DEVELOPMENT REVIEW COMMITTEE (DRC) COMMENT REPORT

Project Name: A & N Properties / Bridge Point I-95

Case Number: R15027

Request: Site Plan Level III Review: 306,520sf Industrial
Development within 300ft of Residential
Development

SITE PLAN

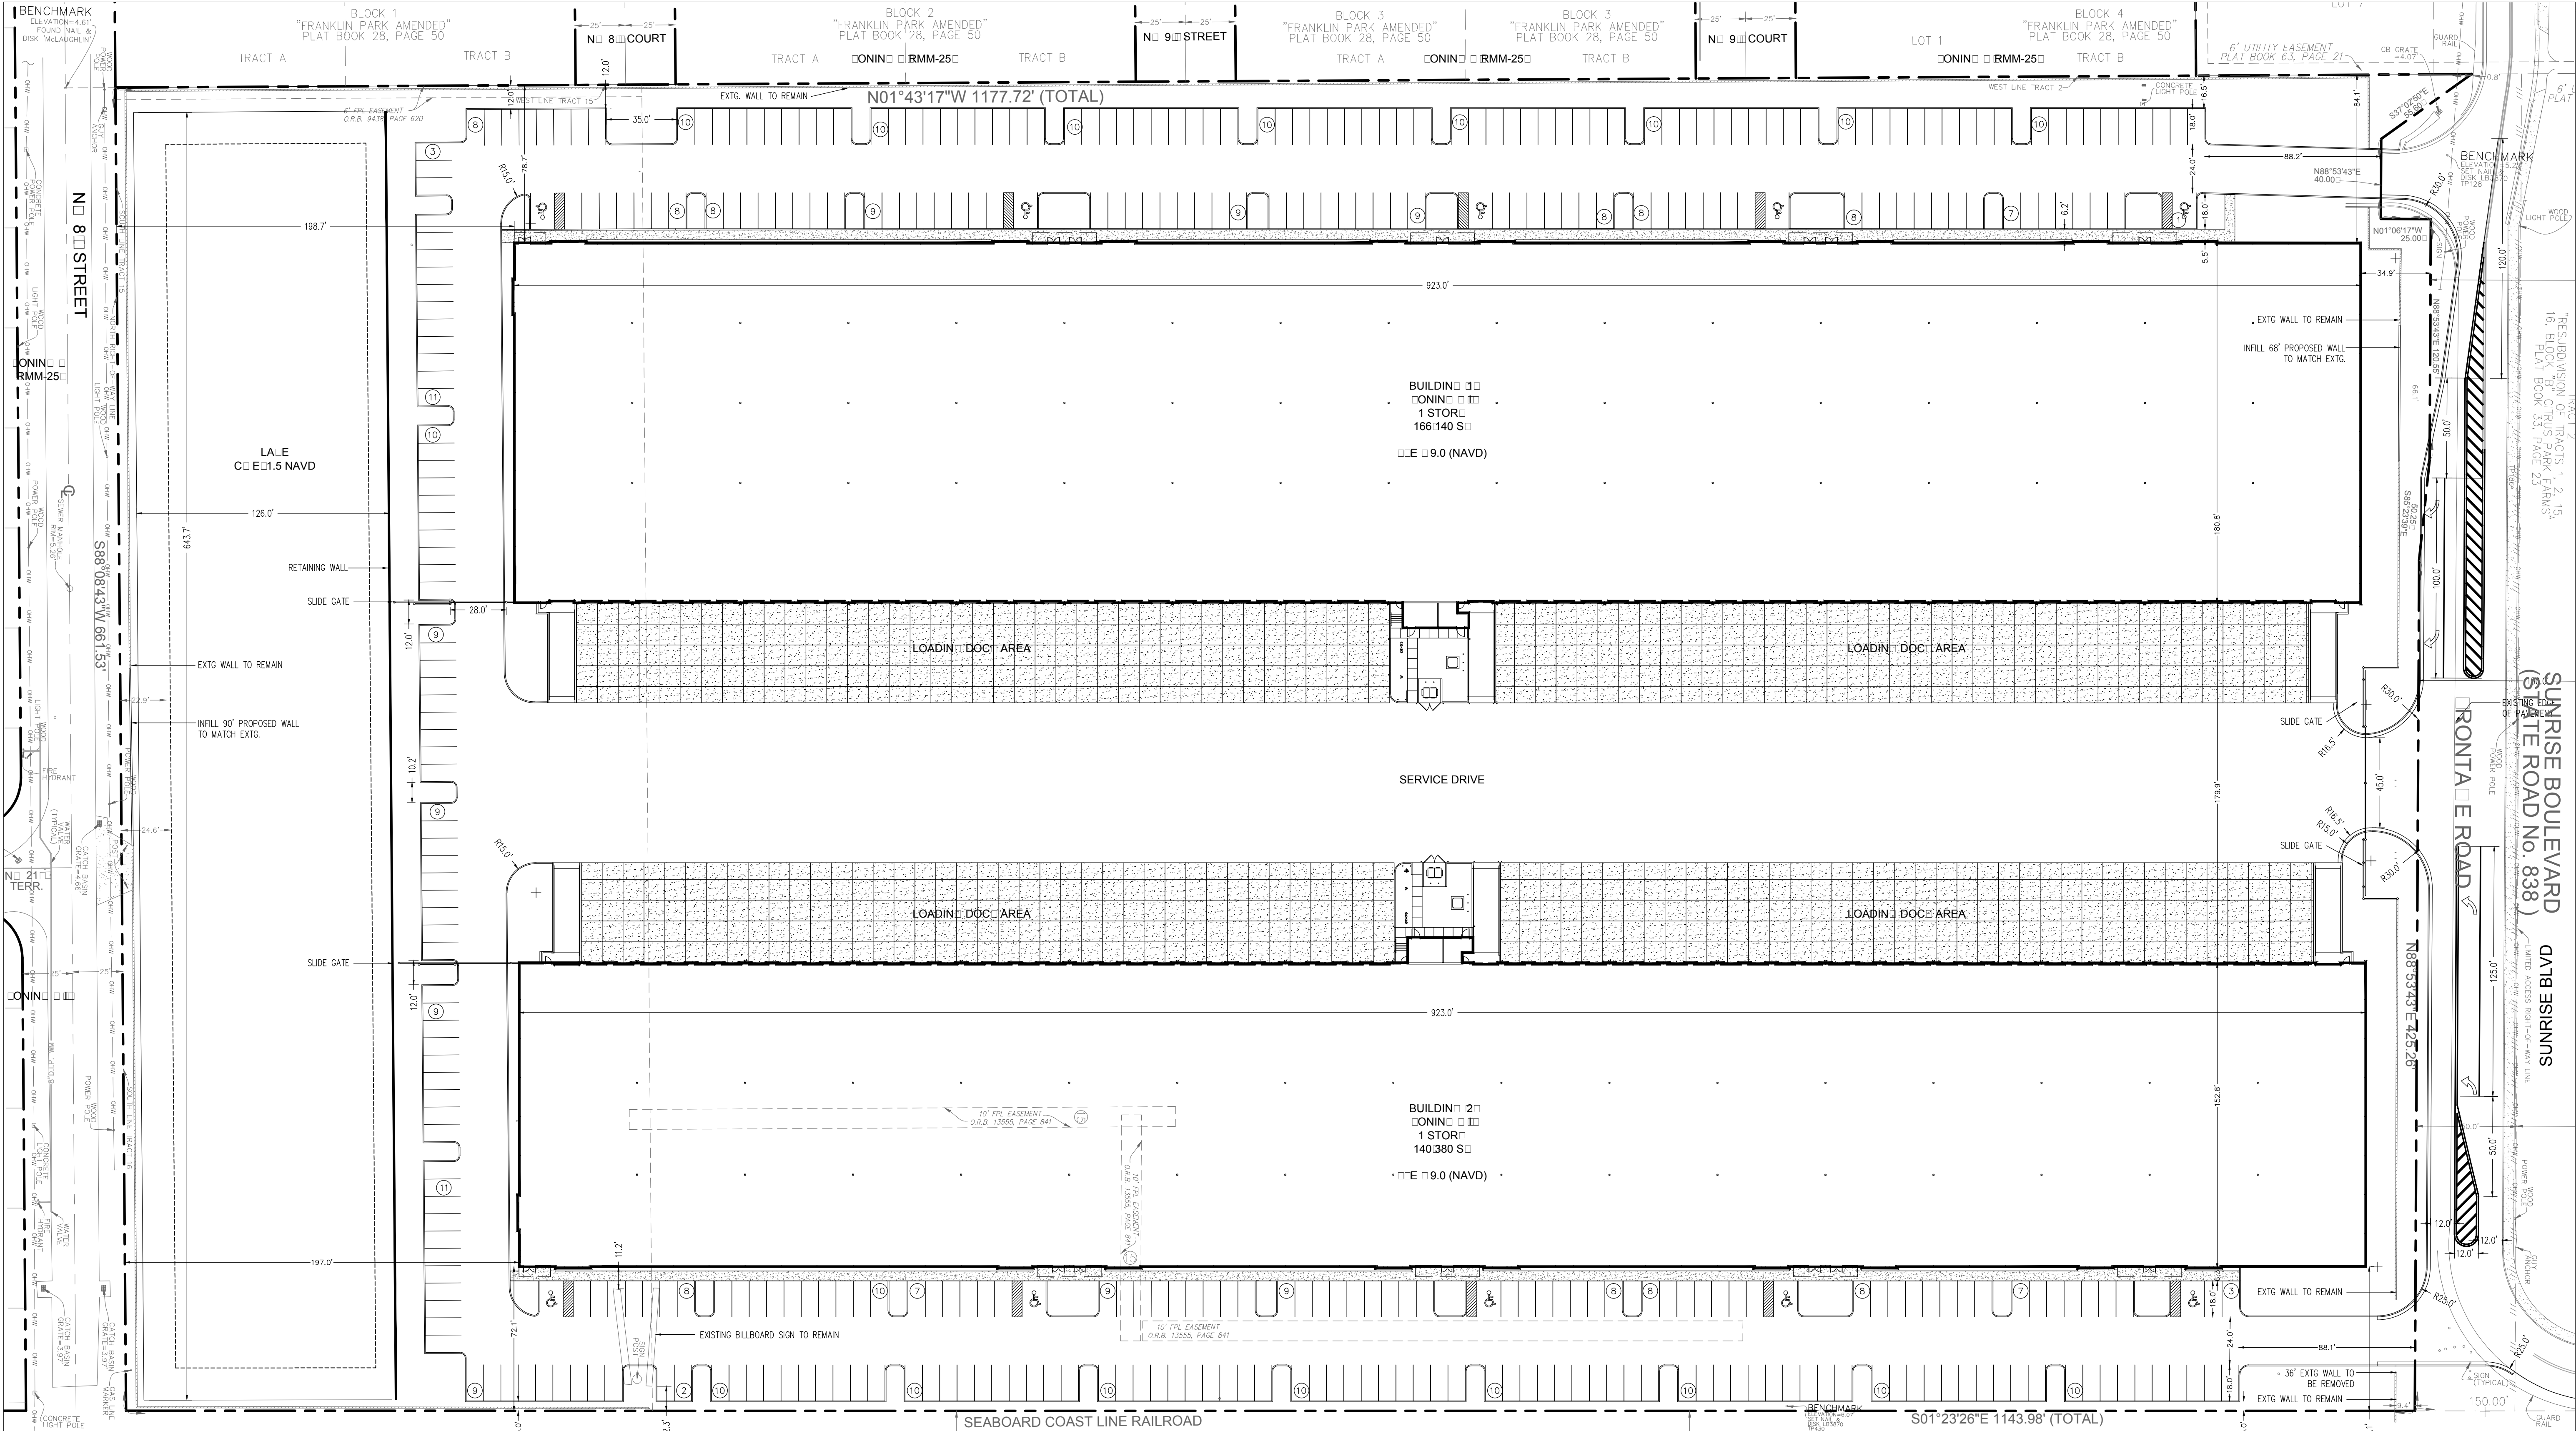
6. Proposed driveway approaches to W. Sunrise Blvd. (Frontage Road) – Show and label sight triangles as appropriate (per ULDR Section 47-2.2.Q), for safe and adequate access of drivers and pedestrians; also, provide FDOT sight triangle on the Site Plan (per the most current FDOT Design Standards).

7. Proposed eastbound W. Sunrise Blvd. (Frontage Road) Right Turn Deceleration Lane doesn't seem appropriate for this project; verify with FDOT, as well as the projected peak-hour right turn movements into the site; adjacent eastbound Frontage Road Thru Lane is shown misaligned through intersection with proposed middle driveway access to the site.

8. Provide and label fire truck turning radius and site circulation.
9. Discuss pedestrian circulation between the proposed development and W. Sunrise Blvd. (Frontage Road); extend sidewalk on south side of Frontage Road, potentially providing connectivity with existing sidewalk on property to the west.

- 11) Indicate whether the 10' FPL Easement shown on the Site Plan will require vacation by means of the City's Easement Vacation process, Sec. 47-24.7.

7. Ensure **site plan** clearly indicates (labeled) locations of all solid waste and recycling containers and/or compactor(s) for all uses as proposed in application. Identify containers.

8. Provide on the site plan a garbage truck turning radii for City review. Drive aisle width and design configuration must allow for safe and efficient maneuverability on-site and off-site. Indicate how truck will circulate to/from/within property.

2. Provide parking calculations, including number of handicapped spots, and total bike parking counts on site plan.
3. Illustrate proposed internal roadway dimensions on site plan.

Drawing Title
EXTERIOR
ELEVATIONS

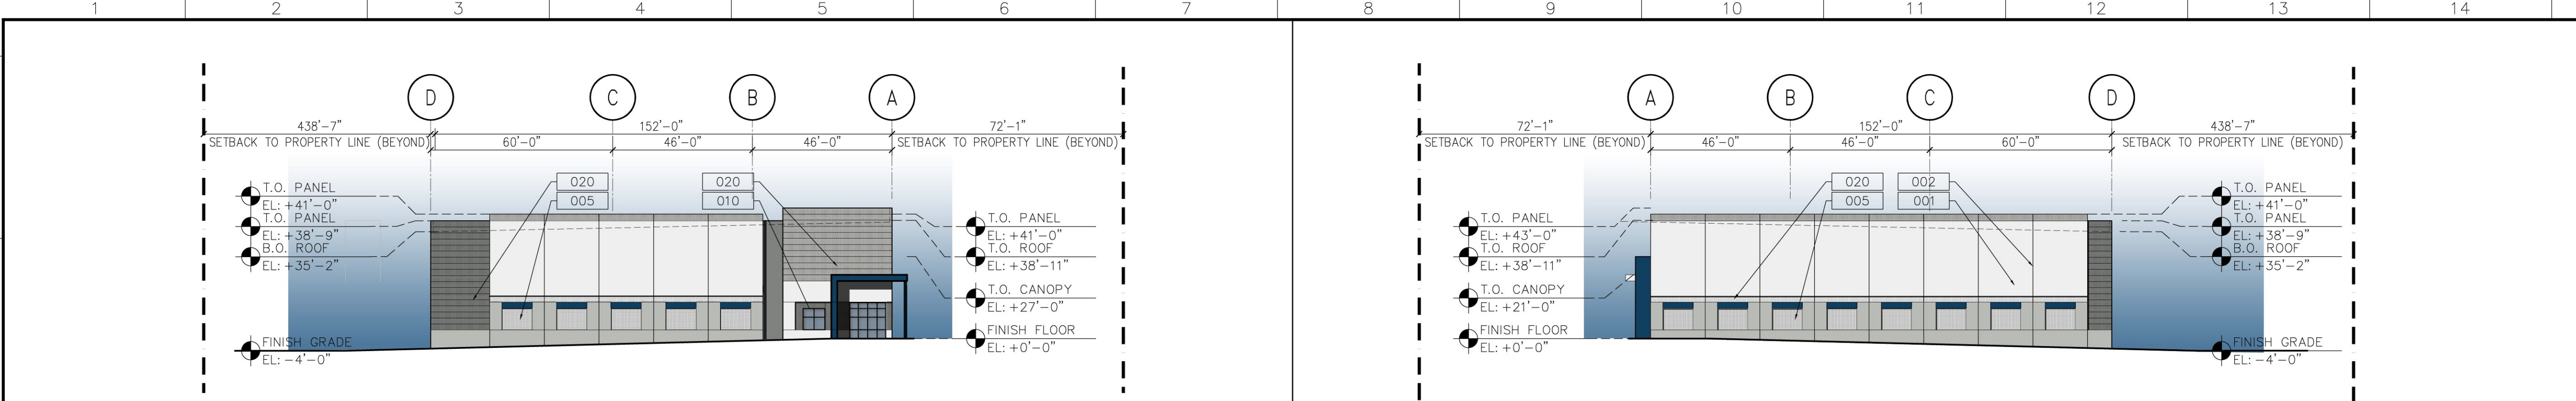
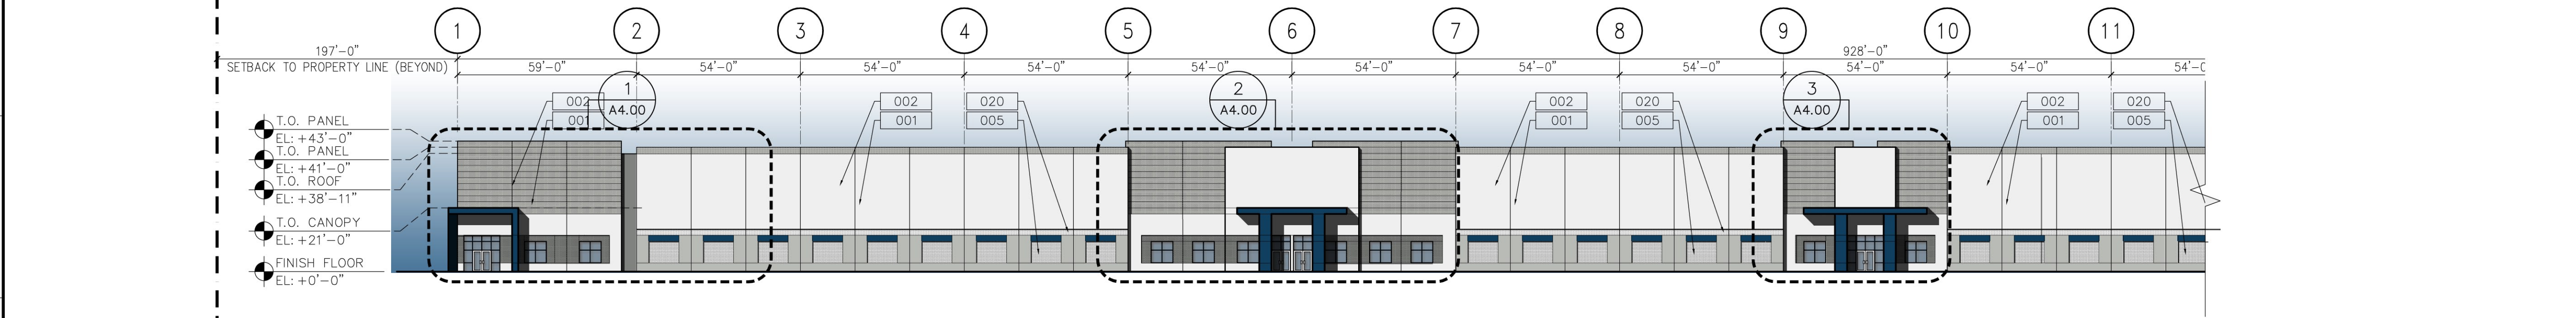
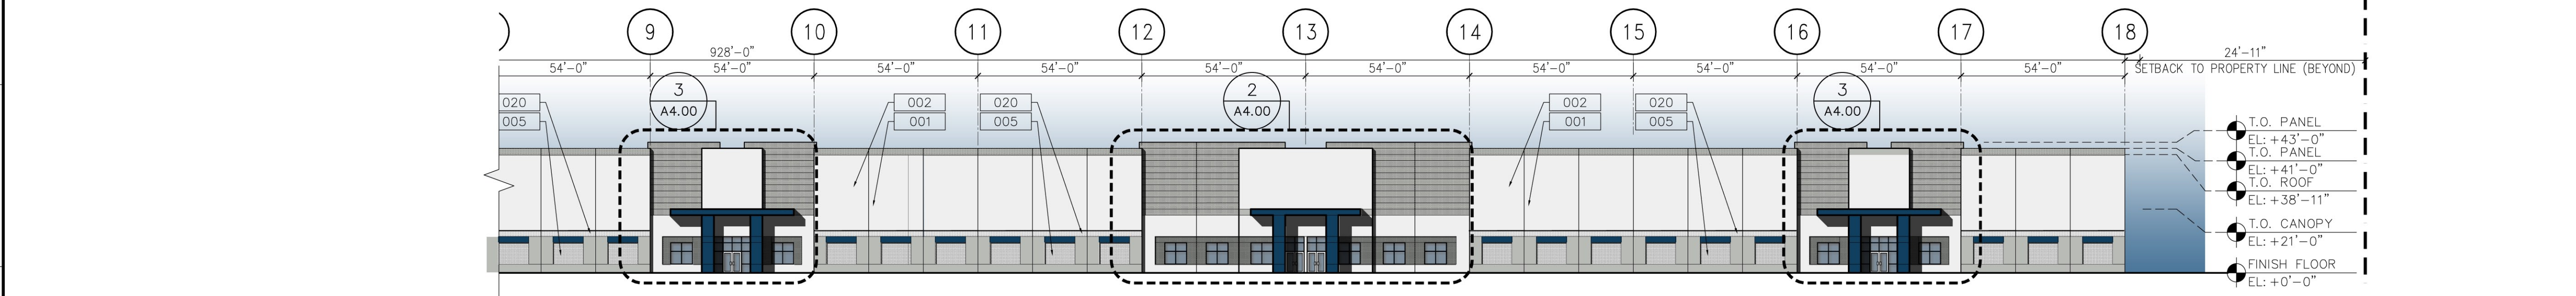
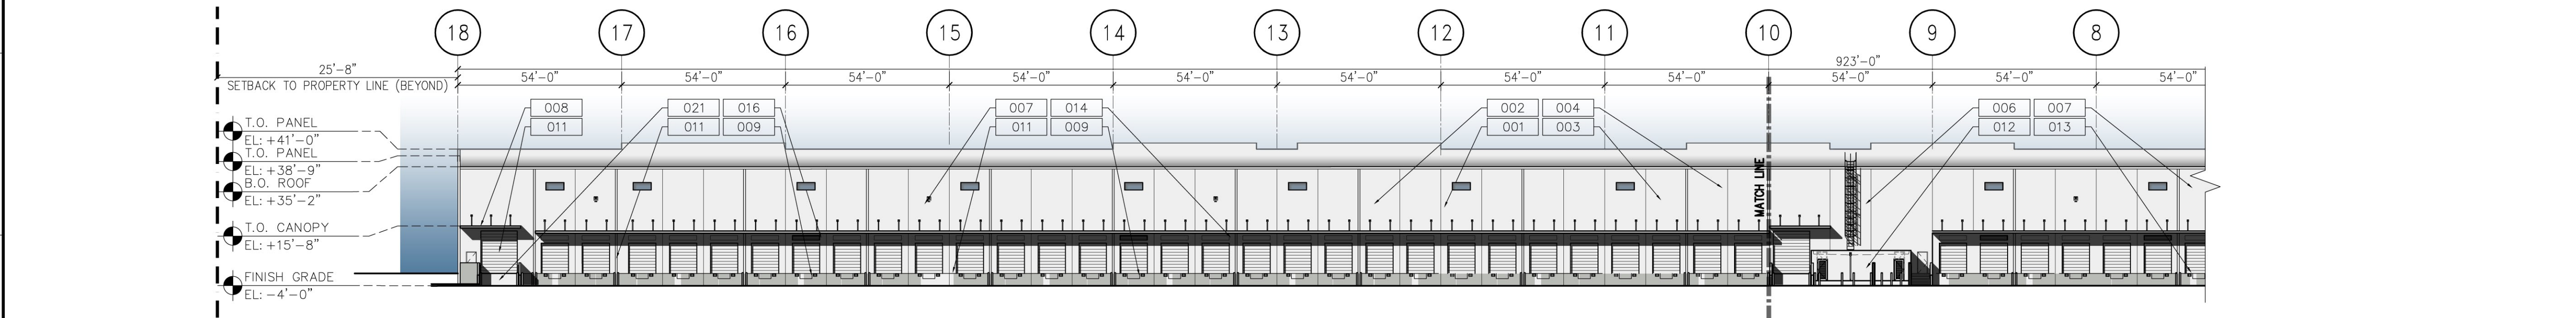
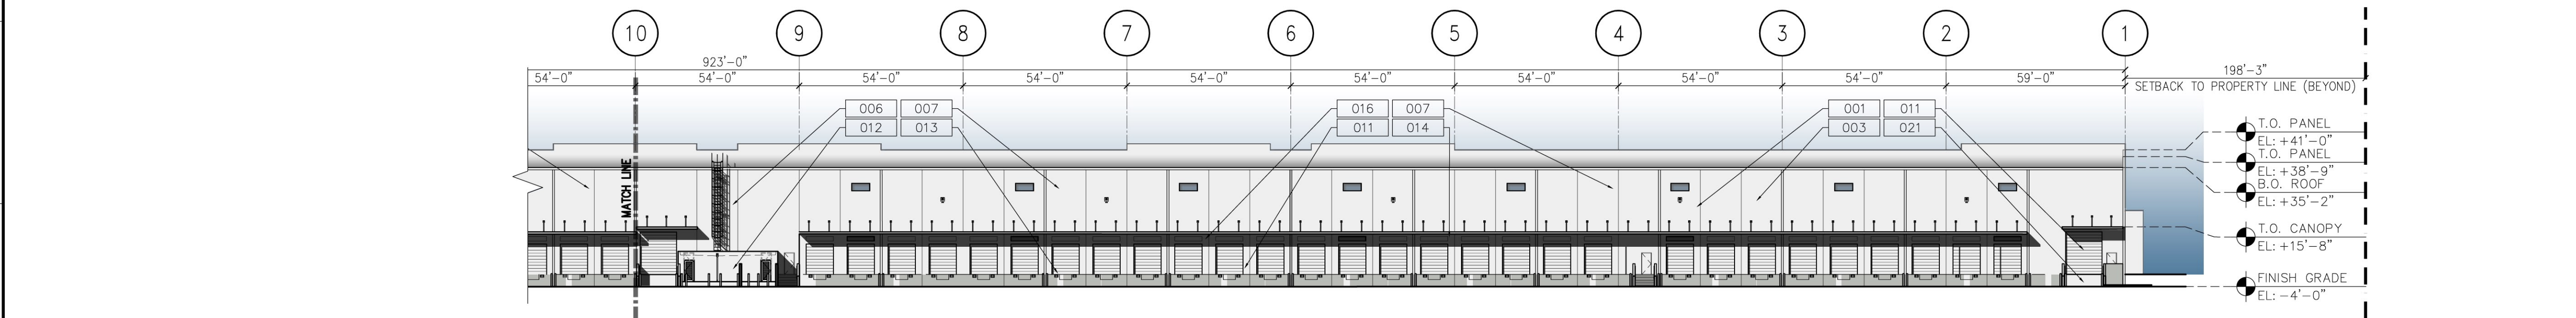
- 8) Replicate similar architectural design features on the north side of the buildings as are currently proposed on the south sides of the buildings.
- 9) Consider lowering the height of the light poles abutting the residential properties to the west of the site.
